DEVELOPMENT REVIEW COMMITTEE (DRC) COMMENT REPORT

PROJECT NAME: Church Property Rezoning

CASE NUMBER: PLN-SITE-20090013

Site Plan Level IV Review: Rezoning from Community

NOTES: DRC Site Plan

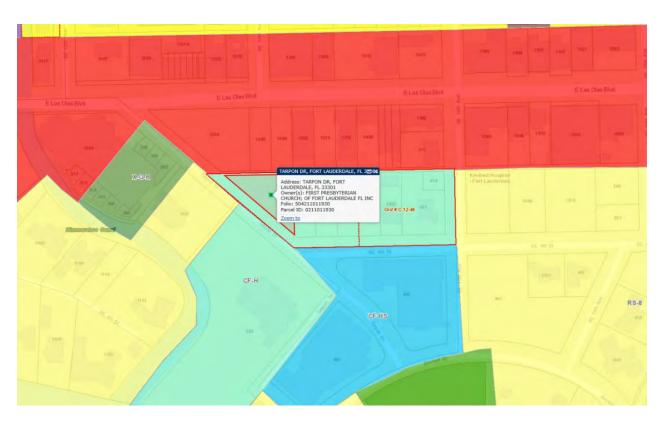
- 9. Request a Zoning and Land use Map of the subject sites from the UDP, Planning Assistant, Maria Roque at mroque@fortlauderdale.gov. Please provide information on both site and address for easier reference. Site to be rezoned to the south is 320 Tarpon Drive and north commercial parcel is 1401 SE 4 Street. See below, per application documents. Please revise application and respective documents to reflect both addresses.
